CORRECTIVE MEASURES STUDY WORK PLAN SOLID WASTE MANAGEMENT UNIT 17  
(SWMU 17) ZONE H CNC CHARLESTON SC  
5/1/2001  
NAVFAC SOUTHERN

# CORRECTIVE MEASURES STUDY WORK PLAN

## Solid Waste Management Unit 17, Zone H

***Revision 1  
Contract N62467-99-C-0960***

Figure 2.5.4A  
 SWMU 17  
 Summary of COCs in Surface Soil

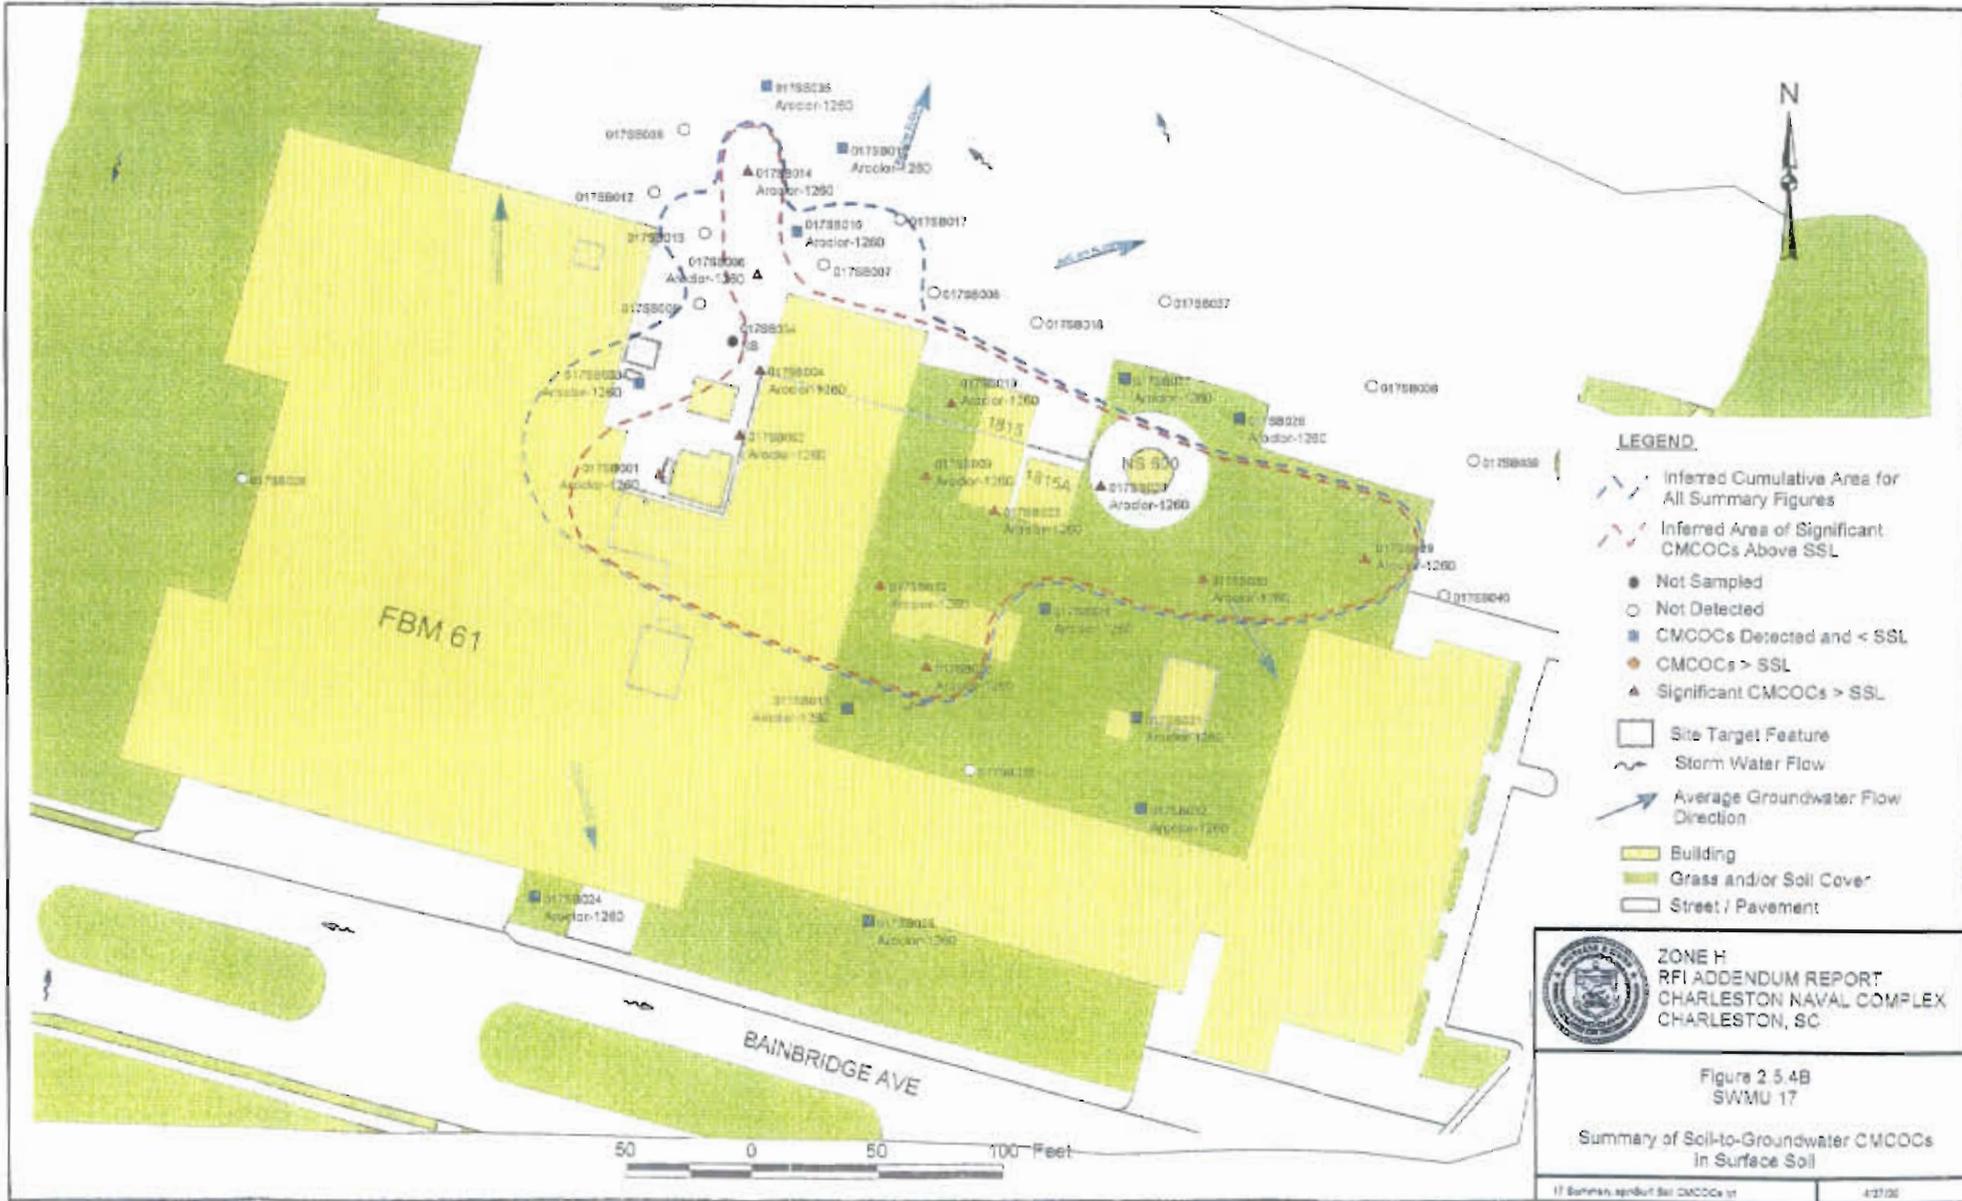
The figures presented in this document should be revised to show the areal extent of COCs above background and risk levels as well as groundwater contours illustrating the extent of PCBs and NAPL. The Department is not requiring additional figures, but recommends revising the current ones.

*1. We will provide selected figures from the RFI Addendum Report as an Appendix to the CMS Work Plan. These figures will include the SWMU boundary, contour maps showing the extent of contamination, groundwater flow direction, NAPL extent, and hydrogeologic cross sections that reflect the understanding of the site conditions at the time that the RFI Addendum was prepared. An appropriate reference to these figures will be made in Section 1 of the CMS Work Plan. Most of these issues (SWMU boundary, geologic cross sections, groundwater flow direction, NAPL extent) are adequate representations of these issues for the purposes of this CMS WP.*

Figure 2.5.4A Summary of COCs in Surface Soil
